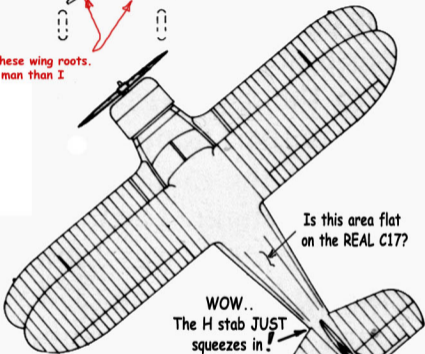
What a nightmare, these wing roots.
You're a better man than I

Is this area flat
on the REAL C17?

WOW..
The H stab JUST
squeezes in!

This air-flow gap
is important and
easy to create

Your Vert F in isn't quite
as curved aft as this one is.
Is it JUST this three view?.
